13 Regents Park Road
London NW1 7TL

Basement Impact Assessment
Audit

For
London Borough of Camden

Project Number: 13693-03
Revision: F1

Plan of Sensitive Structures

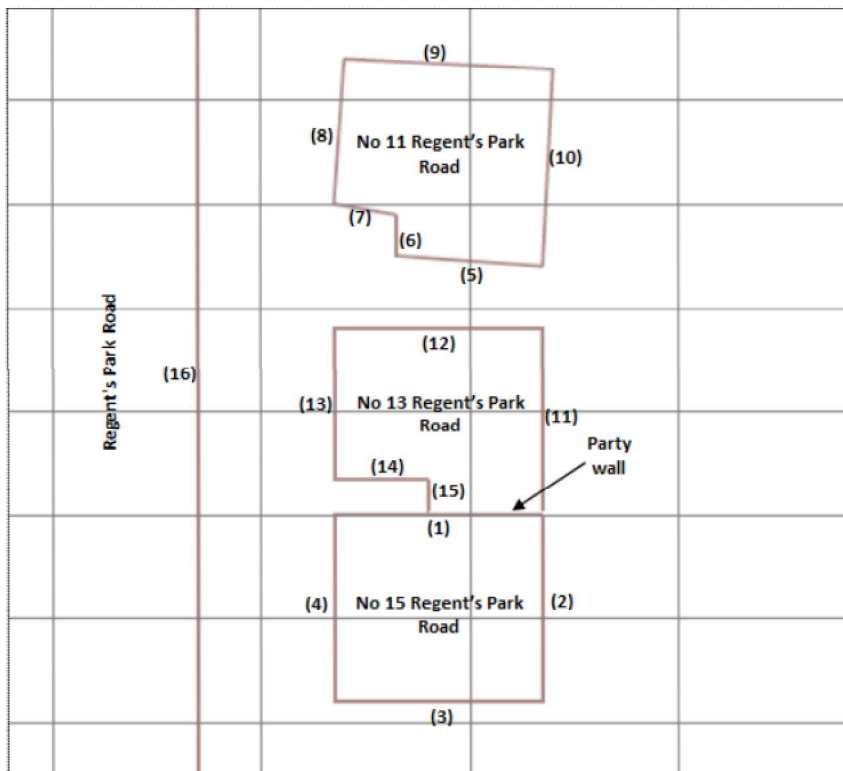
- 3). The GMA should consider also the properties above, with damage level explicitly stated.
- 4). The BIA by Morph and the screening exercise by GEA are contradictory regarding the removal of trees. The screening does not identify that a tree in the lightwell is to be removed. Section 6.2 of the BIA does not explain how the influence of the boundary wall reduces the impact of the roots on the basement and it does not consider the impacts of tree removal and incursion into root zones on surrounding shallower foundations (ie foundations of the neighbouring structures).

3. As it is understood that ownership of the property on site is shared, with the upper part of the building belonging to another individual, we have updated our models to include this structure within the analysis and subsequent damage assessment. The inputs, contour outputs and damage assessment tables are included in the link below, with an amended plan of sensitive structures and an updated table of results included below.

The building damage reports for sensitive structures highlighted in the above table predict that the damage to the adjoining and nearby structures would generally be Category 0 (negligible), with Category 1 (very slight) damage to the front and rear elevations of No 15 Regent's Park Road (Ref Nos 2 and 4), the rear elevation of No 13 Regent's Park Road (Ref No 11) and the side and rear elevations of No 11 Regent's Park Road (Ref Nos 6 and 10).
